Historic Landmarks and Preservation Districts Commission

Report to the Committee

Case No: 22-COA-0112
Classification: Committee Review

Property Address: 141 Pope Street

West Elevation 1st level original front facing windows

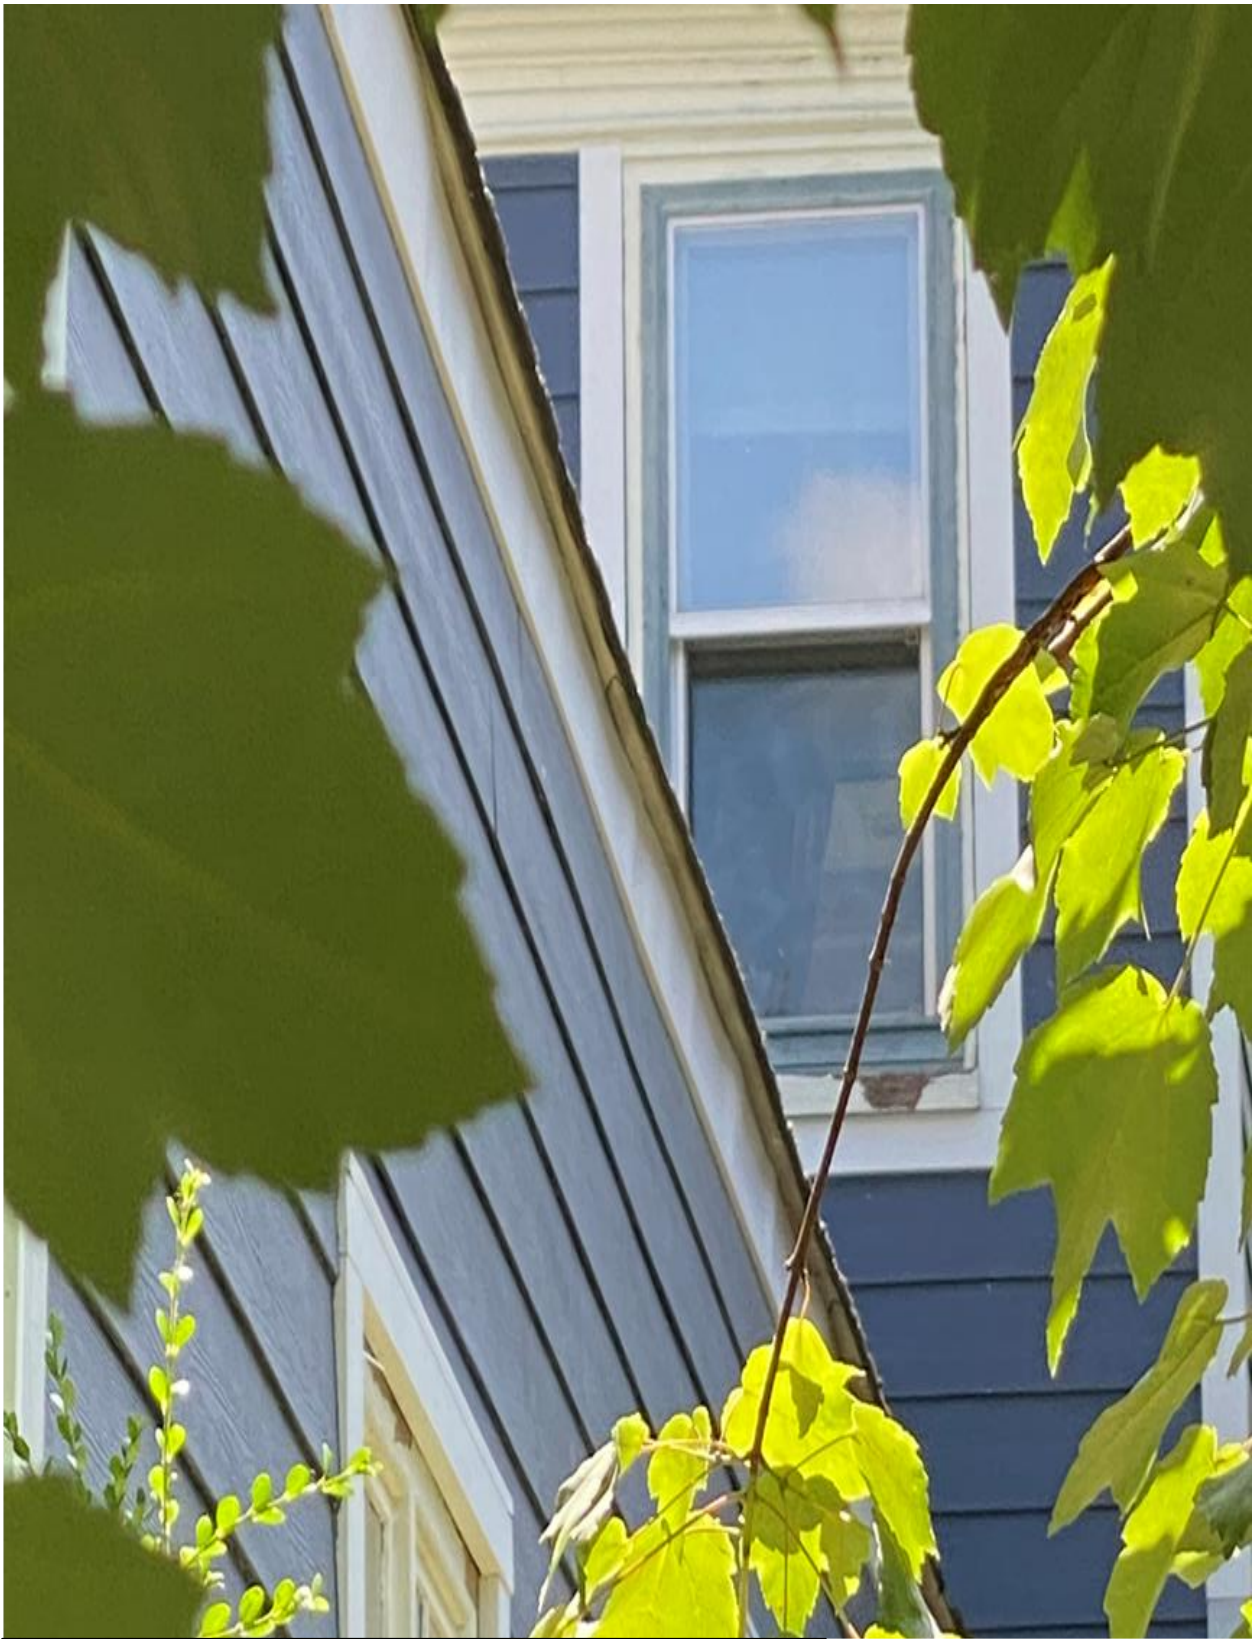
The proposed after-the-fact front facing windows generally do not meet the Clifton design guidelines for **Window**. Two of the three after-the-fact replacement windows no longer have the same one-over-one muntin pattern as the original windows did. They are now six-over-six, which does not meet W1 or W2. All three after-the-fact windows have been replaced with United 9600 Series vinyl composite replacement windows. Vinyl windows do not have the same profiles or dimensions as historic wood windows. While the design guidelines allow for synthetic, they do still have to match the historic windows. Staff recommends a different material than vinyl for the front window replacement. Furthermore, the windows should be replaced with new ones that are one-over-one to match the historic configuration.

1. The three after-the-fact replacement windows shall be replaced with one-over-one replacement windows that closely match the dimensions of the historic wood windows.
2. The replacement windows for the two front facing second-story windows shall be one-over-one and shall closely match the dimensions of the historic wood windows..
3. All glass shall be clear and non-reflective.
4. The applicant shall not wrap the window trim or sills with vinyl or aluminum.
5. The applicant shall take precautions to preserve any existing wood elements to be reapplied to the building and shall submit photographs of all elements proposed to be reconstructed.
6. The applicant shall take appropriate precautions with the handling of potential lead paint.
